**CITY OF CROSSLAKE
PLANNING COMMISSION/BOARD OF ADJUSTMENT**

PUBLIC HEARING NOTICE

Site Location: 12525 Anchor Pt Rd, Crosslake, MN 56442 on Rush Lake - GD

RE: McGraw property Variance Requests; Rush Lake (DOW# 18031100); Crow Wing County

CERTIFICATE OF SURVEY
McGraw Property
Ron Schultz
R & R Schultz Custom Homes
8890 Rutiger Road
Pequot Lakes, MN 56472

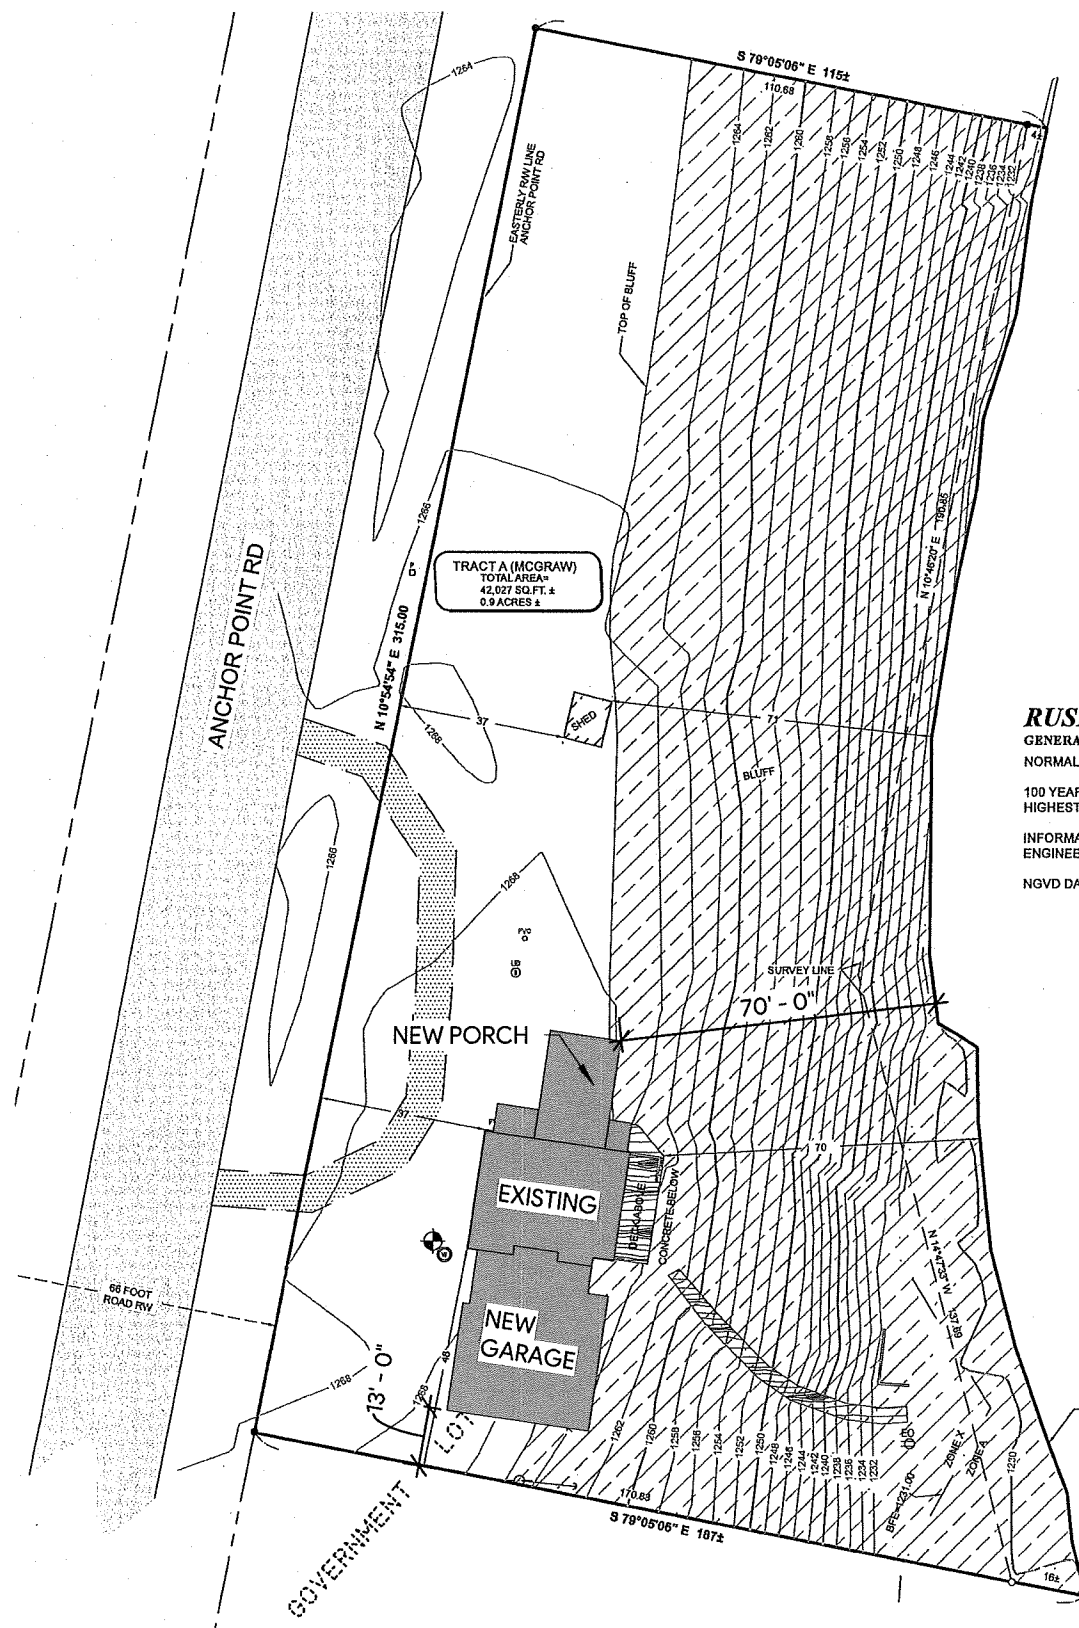
On December 29, 2025, I personally visited the subject property with Zoning Director Jody Grund. Based on my review of the City's Ordinance, site visit information, the variance application packet including COS, and analyzing statutory criteria for variance approvals, **the DNR recommends denial of all the above variance requests as written, and at a minimum no dirt moving or structures should be located within the bluff itself.** Specifically:

- There are no unique circumstances to the property not created by the property owner. After reviewing the certificate of survey and performing an on-site visit to the property, it is clear there are locations in the rear lot zone (towards the road right-of-way) that offer suitable alternatives for the construction of an addition/garage and porch. The south side of the property includes a level surface with no SSTS obstructions or adverse grades which would prevent the proposed garage/addition to be slid backwards to avoid direct impacts within the bluff. This may mean re-designing the configuration or reducing the footprint of the addition.. The north side of the property includes the obstacle of a proposed new septic system for which a 10-foot setback to the septic tank must be met, but there still appears to be ample room for the porch to be slid back towards the road right-of-way and still meet the 10-foot SSTS setback. Sliding both proposed structures back towards the road right of way would therefore eliminate any grading within the bluff and further prevent intensive vegetation removal in the bluff as well. It may also result in the removal of a variance for lake setback as it will be at a greater distance than currently proposed.

1. No dirt moving associated with footings construction, general landscaping, or stormwater plan features shall be conducted within the actual bluff itself, as shown on the COS dated 11/13/2025

2. The top of bluff must be clearly staked out and labeled prior to the start of construction for the project. Temporary Best Management Practices (BMPs) must be installed at least at the top of the bluff to prevent stormwater runoff associated with construction from traveling down-hill.

3. A stormwater management plan treating all impervious surfaces on the property must be submitted for City staff approval at the time of land use permit application, and implemented by project completed or permit expiration, whichever comes first. No storm water management retention/features may be constructed/placed within the bluff itself, including “french drains.”

4. No natural vegetation (i.e., trees/shrubs/plants) may be removed within the bluff and bluff impact zone unless removal occurs where a proposed structure is to be placed.
